Delegated Report

Application no: 20230202

Location: Ascot Arms Central Avenue Gravesend Kent

Description: Application for the approval of condition 12 attached to planning permission 20220207 relating to full details of any proposed earthworks or changes to ground levels on the site including details of any earth retention measures have been submitted to and approved.

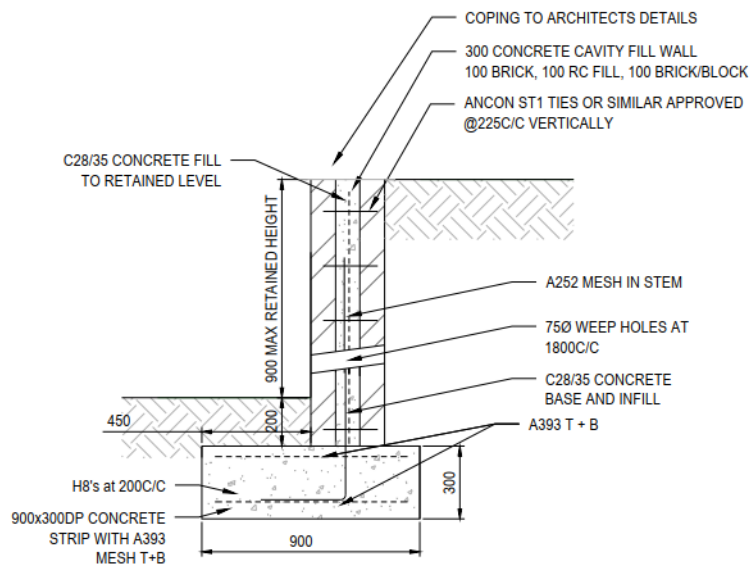
The submitted information shows there would be no significant changes in the land levels of the site, the highest increase would be +36.580 and the changes would consist for changes in kerb levels etc.

RETAINING WALL DETAIL
MAX 0.9m RETAINED HEIGHT WITH PARAPET
 SCALE 1:20

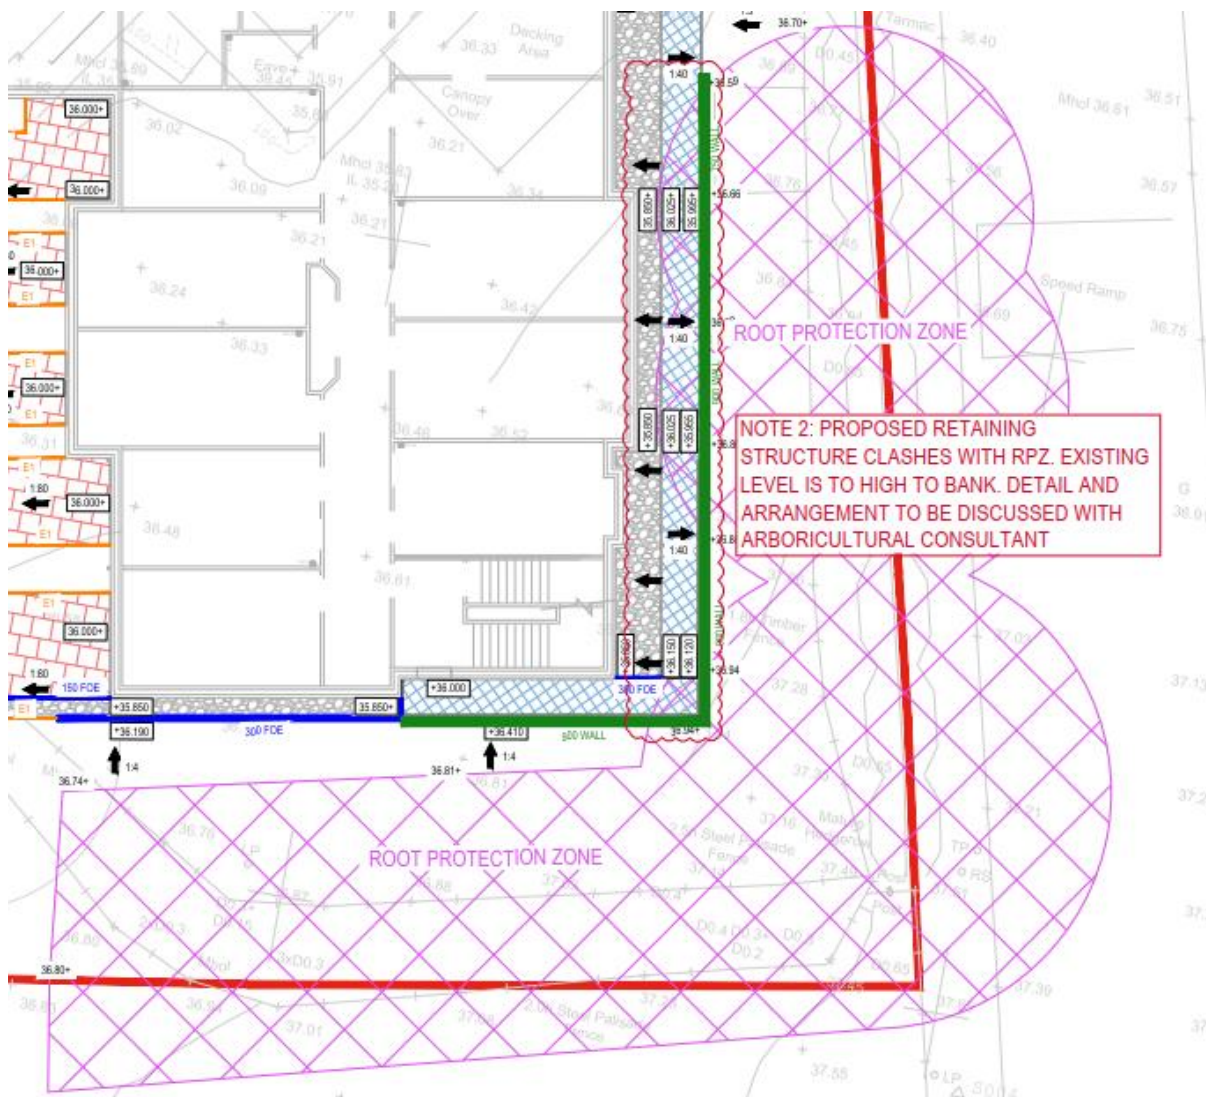
In terms of earth retention measures there is a retaining wall proposed in the north-western corner of the site which would be 900mm in height:

The retaining wall structure would be located in the Root Protection Zone (RPZ) of T11-T14 and as such there is concern at the potential impact the proposed retaining wall would have on the tree roots in the RPZ:

It is noted that on drawing no. 22 026 – ARC – XX – XX – DR – C – 0601 – T4 – External Works General Arrangement that it is stated that the retaining wall would be partly located in the RPA and that the detail and arrangement is to be discussed with an Arboricultural Consultant.

The retaining wall by its nature would have the potential for a greater impact on the RPA of T11-T14 than the path.

The agent was asked to provide a view from an Arboricultural Consultant at this stage on what impact the retaining wall would have on the RPZ of T11-T14 and that this would not be able to be left for discussion at a later date but the Council would need to know the impact at this approval of details stage before it can ascertain whether the retaining wall would be acceptable or not.

The agent has provided a response from the original Arboricultural Consultant who wrote the original Arboricultural Report. The Arboricultural Consultant states his original report covers how the works proposed in the RPZ of T11-T14 will be addressed which will be opening the ground initially with hand tools and under arboricultural supervision. He advises that because the trees are on a slightly higher ground level, it is feasible that most of the rooting mass will be focussed on the upper level where moisture and gaseous exchange will be better for them. Furthermore, the Arboriculturalist advises that he can supervise any excavation works in this area as part of the ongoing arboricultural supervision, ensuring that any roots encountered are suitably protected and covered.

The response from the Arboricultural Consultant is considered to provide reassurance that a sufficient methodology will be in place to ensure that the RPZ of T11-T14 will not be unduly harmed.
